KSI - VAN DORN STATION PROPOSAL

DSUP #2001-0024
SUP #2001-0115

Docket Item #19-A
DEVELOPMENT SPECIAL USE PERMIT #2001-0024
KSI/VAN DORN STATION PROPOSAL

ISSUE: Consideration of a request for development special use permits, with a site plan, for construction of a residential development with associated parking, an increase in the overall floor area ratio, establishment of residential use within 1,000 feet of Eisenhower Avenue, retail and personal service space with associated parking and Metro parking spaces, a restaurant with outdoor seating, and a reduction in the size of the required parking spaces. Associated with the special use permits is an associated request for a construction sales trailer. The applicant is also requesting approval of a Transportation Management Plan.

Site Layout

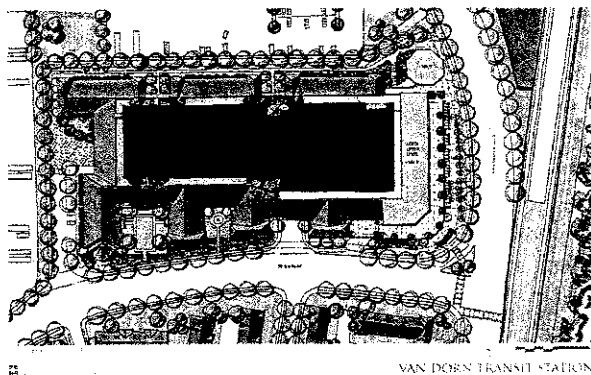
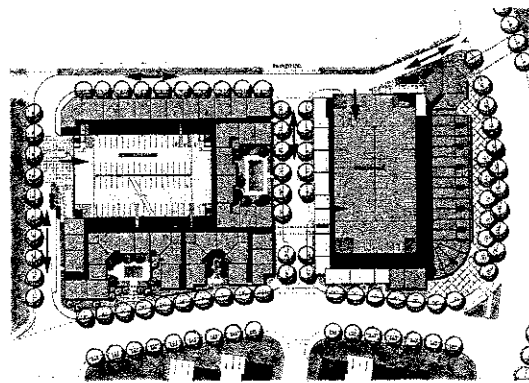
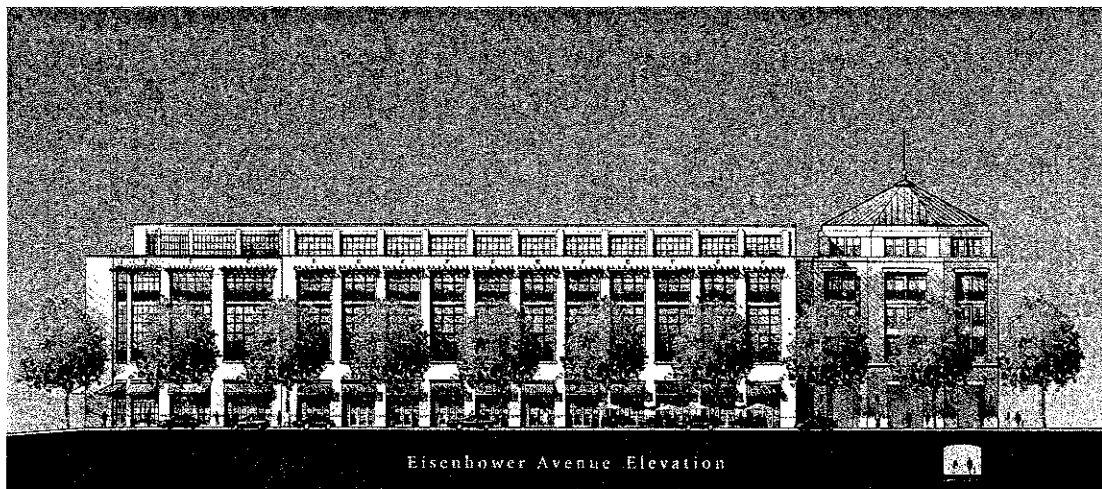
The original plan submitted by the applicant to the City proposed a similar development but without the introduction of any internal street network. Staff identified several key issues:

The revised design addresses the fire-safety issues and shifts access to garages and loading from the external streets to internal streets. The grid also helps to break up some of the mass of the development by creating two separate blocks, each approximately 250 to 350 feet in length. Unfortunately, the break between the two blocks is not entirely open, as the applicant proposes walkways across the street at the upper levels so that residents in the southern block can access the residential parking garage in the northern block. Also, staff had asked that the streets be designed to public street standards, with two lanes of traffic, two lanes of parking and sidewalks and street trees. This has been accomplished on portions of the east-west streets, but the applicant has not provided sufficient width on the north-south street for any parking, and in all cases, the width of the sidewalks/street tree area is narrower than would be provided on a public street.

While not optimally designed, the introduction of the street network is a positive element in the plan which staff supports, and which may be able to be utilized to provide access to the adjoining UPS parcel in the future, if it redevelops. Staff is recommending that full public access easements be granted over the streets and sidewalks so that the site will be truly permeable from the public's perspective.

In response, the applicant revised the plan to introduce the current street system.

Eisenhower Avenue Frontage Features

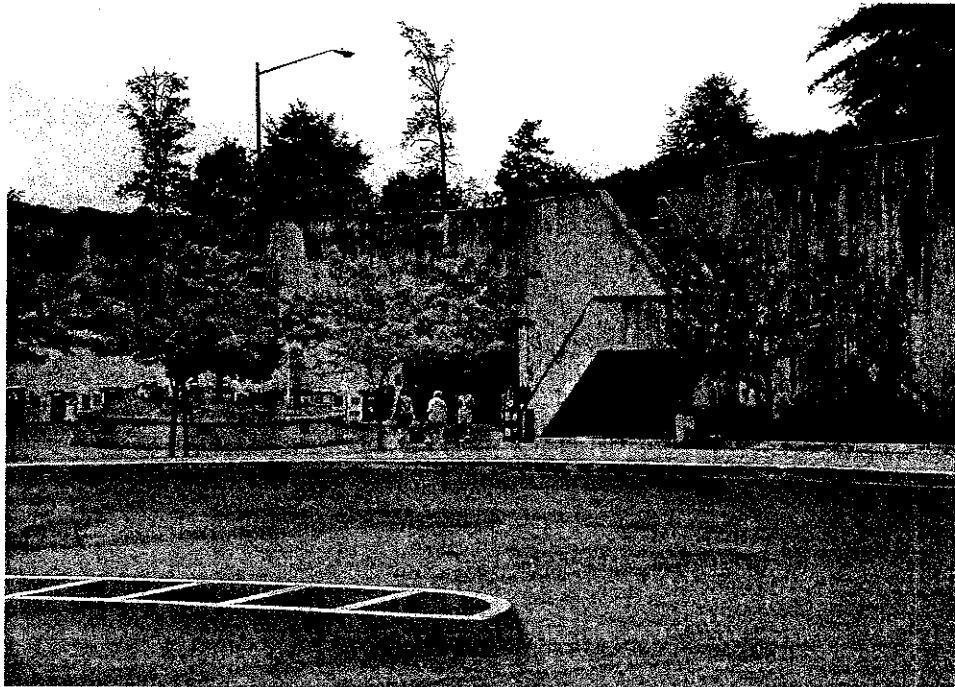
The applicant has also been responsive to requests by the City to redesign the frontage along Eisenhower Avenue to provide a generous sidewalk that incorporates the bike trail that runs along this frontage. The Eisenhower Avenue frontage will feature a 6 foot wide street tree planting strip adjacent to the north curb of Eisenhower Avenue, a full 10 foot wide bike path, and a decorative sidewalk. The trail will be of a surface treatment and coloring different than the remaining sidewalk to visually delineate the difference in use. Beyond that, a sidewalk ranging in width from 6 to 24 feet, will include a second row of ornamental trees. The sidewalk area will be designed as a scored concrete promenade with paver bands and will feature decorative tree grates, benches, trash receptacles, and outdoor seating for the proposed restaurant use.

Unfortunately, because of the curvature of the frontage, the narrowest portion of the sidewalk—6'-- is located adjacent to the Metro Station entrance, in the very location where a broader sidewalk and larger public plaza would be most appropriate. Staff had originally asked the applicant to provide a larger plaza area adjacent to the Metro station entrance, to serve as a focal point at the Metro Station for future redevelopment. However, absent any plan for the larger area it is difficult in this instance to design and require such a space in the context of this project. Staff has requested that the design be adjusted to allow escalators to be installed in the future at the Metro entrance; while current ridership does not warrant escalators according to Metro standards, future ridership may make such escalators desirable. Providing space for these escalators may result in a larger plaza area being created for their future accommodation.

Cross-Elevation of WMATA Garage, depicting kiss-and-ride level below grade:

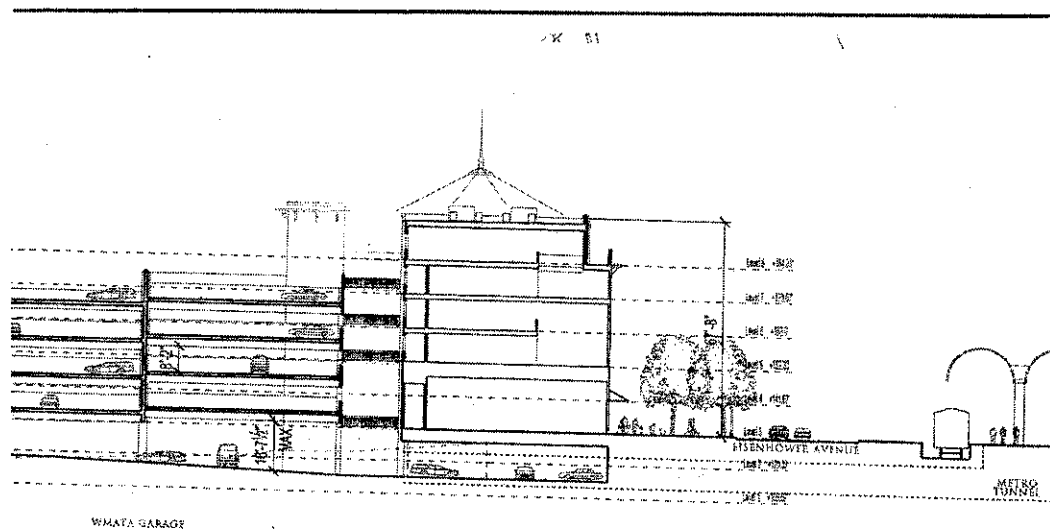
As proposed, the kiss and ride facilities would be located at the same grade as the current parking lot, on the ground level of the parking structure. The subject property is approximately 14' lower than the grade of Eisenhower Avenue, so the parking lot is below the level of the street, roughly at the same level as the tunnel that connects under Eisenhower Avenue to the Metro station. While the site today is "in a hole," the existing lot nonetheless has good visibility in each direction, and users of the lot are oriented to the Metro station by being able to see the station across Eisenhower Avenue. As proposed, the new "kiss and ride" function will effectively remain at the same level it is today, becoming the ground level of the six level parking structure, with a garage built overtop and residential and retail uses wrapped around the perimeter.

Staff is concerned that although technically the "Kiss and Ride" garage is not underground, it will feel and function as though it is underground, with limited visibility. While this arrangement has the benefit of leaving the "Kiss and Ride" function at the same level as the tunnel entrance into the Metro, staff is concerned that the "Kiss and Ride" function may not operate as well in its buried location.

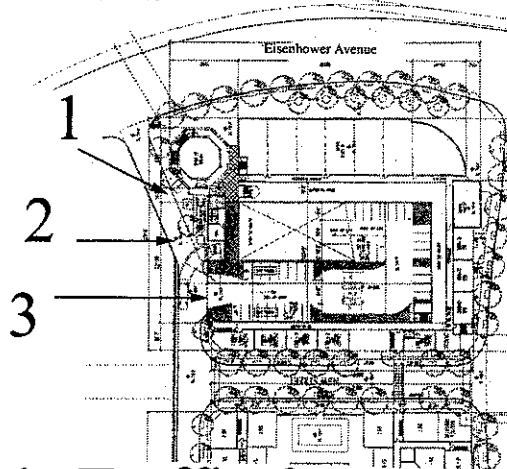
- The structure will eliminate the current visibility of the kiss and ride facility from Eisenhower Avenue and northbound traffic on Metro Road, creating the potential for confusion as to the facility's location that could impact traffic flow and facilitate congestion in the area. The applicant provided a "wayfinding" signage package that could partially address this concern; however, the amount of signage that has been included to direct patrons through the site could be evidence of the design difficulties presented by the applicant's proposal.

- Staff is also concerned that while the parking level is not technically underground, because views are completely obstructed by the surrounding buildings and little natural light will reach the interior it will look and feel to the queuing vehicles and waiting patrons as if it is underground, and patrons may feel the same discomfort waiting in the garage as they would an underground garage. If patrons do not feel comfortable waiting in the enclosed garage, they may choose to wait above grade on the street, creating traffic congestion when vehicles stop to pick them up along the roads driveways or Eisenhower Avenue. Also, vehicles dropping off patrons may find it more convenient to drop patrons off at street level, along the new roadway near the Metro entrance, rather than entering and circulating through the enclosed garage; this could cause significant congestion and traffic-back up on Eisenhower Avenue, of significant concern to T&ES staff. While theoretically it should be no more difficult for a vehicle to enter and circulate through a garage than it would have been for them to circulate through an open parking lot, the physical structure and idea of a garage will undoubtedly create some psychological deterrence for some.
